Access Compliance Report Public Rights-of-Way (Curb Ramps)

Main Street: WEST_KNOLL_DR Cross Street: WENDOVER_RD Location: NE

ADA ID: RPAT211115133841 Ramp Type: Type 1 - Perpendicular Diagonal Initial Pass/Fail: Pass Overall Compliance: No Severity Score: 0

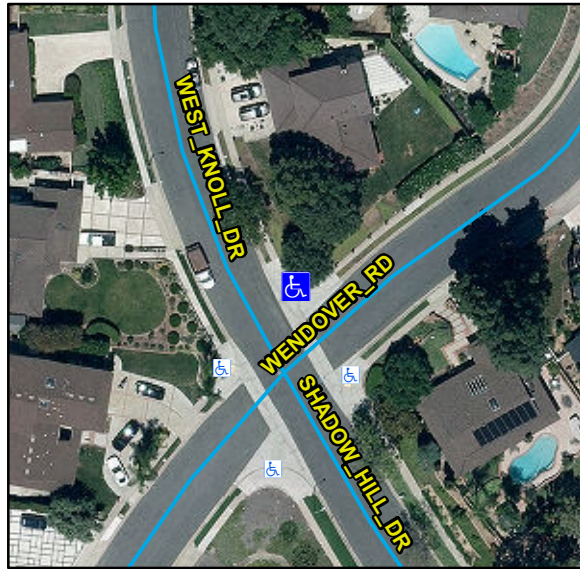
R304.2.2, R304.2.1, R304.2.2-Perp, R304.3.2-Para, STD 1115

Remove & Replace Curb Ramp With Two New Directional Ramps or Equivalent.
